PLANS AND DOCUMENTS referred to in the PDA DEVELOPMENT APPROVAL
Approval no.: **DEV2023/1392**
Date: **1 September 2023**

AMENDED IN RED

PROJECT HUNGRY JACK'S
ALBION
254-270 ABBOTSFORD ROAD
BOWEN HILLS QLD 4006

DRAWING		
PROPOSED SITE & SIGNAGE LOCATION PLAN		
PROJECT NO.	211106	
SCALE	As indicated@A3	DRAWING NO.
		DA01
		REV.
		1

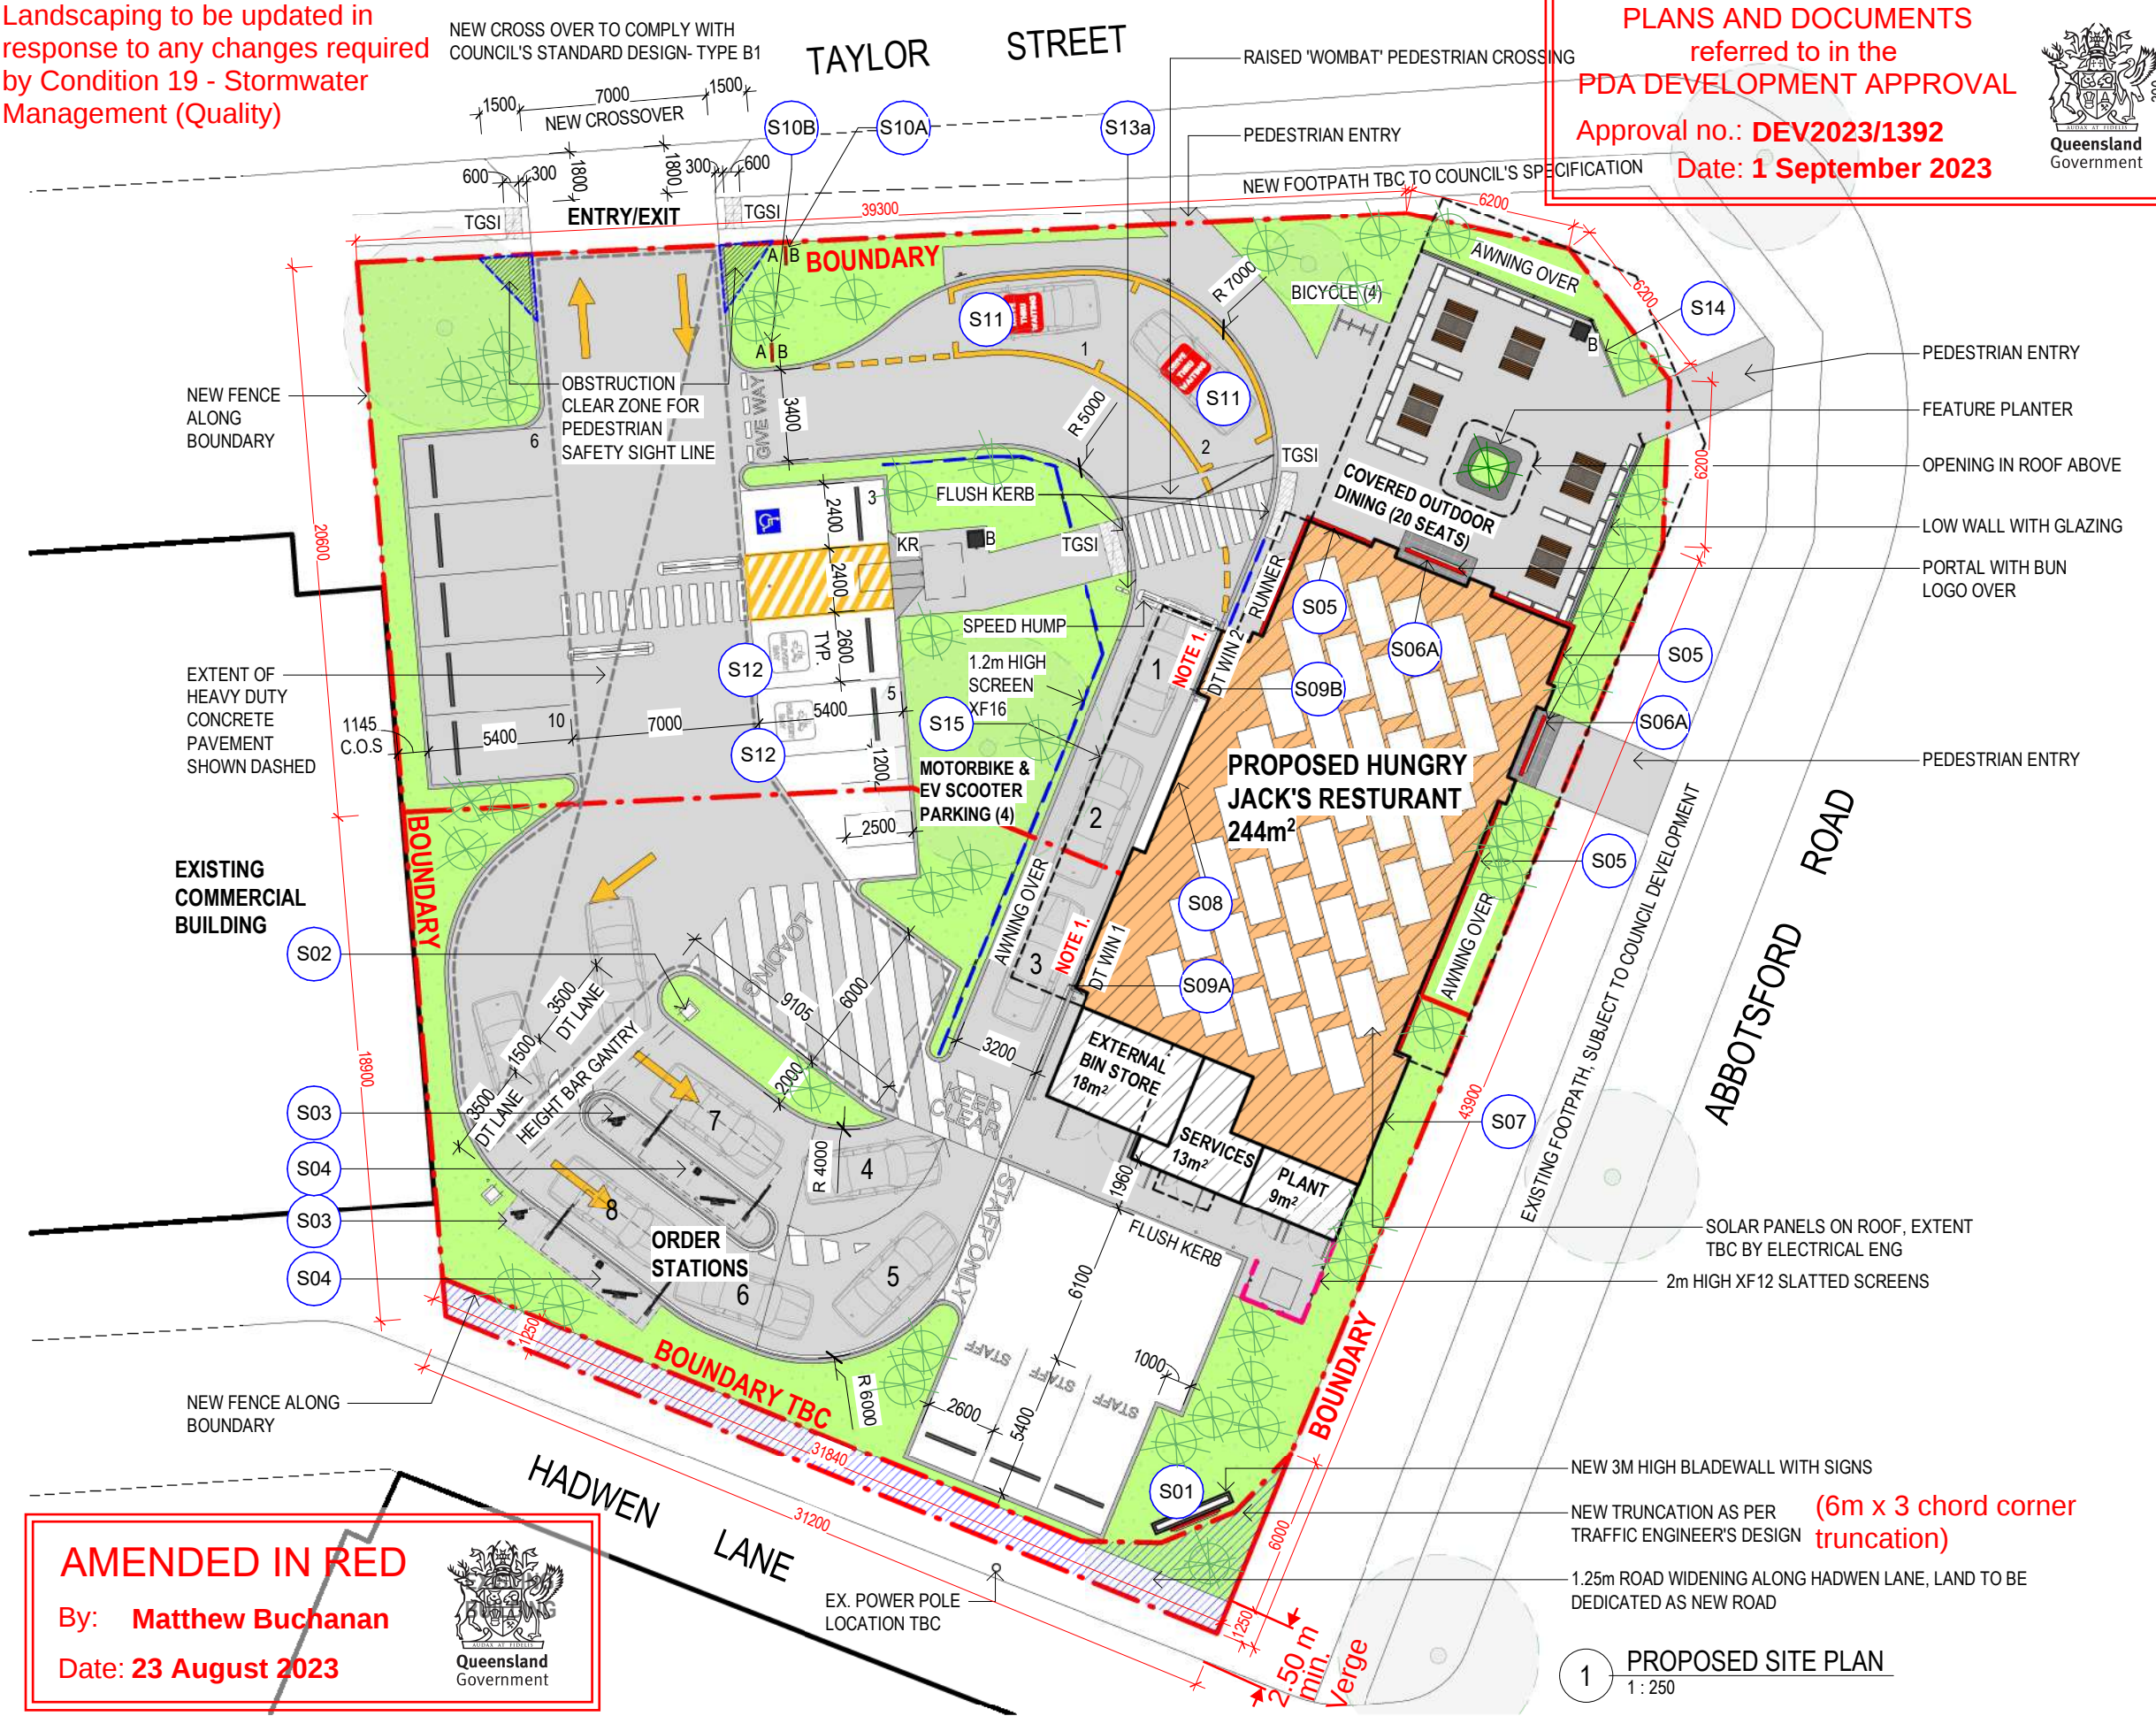
Landscaping to be updated in response to any changes required by Condition 19 - Stormwater Management (Quality)

NEW CROSS OVER TO COMPLY WITH COUNCIL'S STANDARD DESIGN- TYPE B1
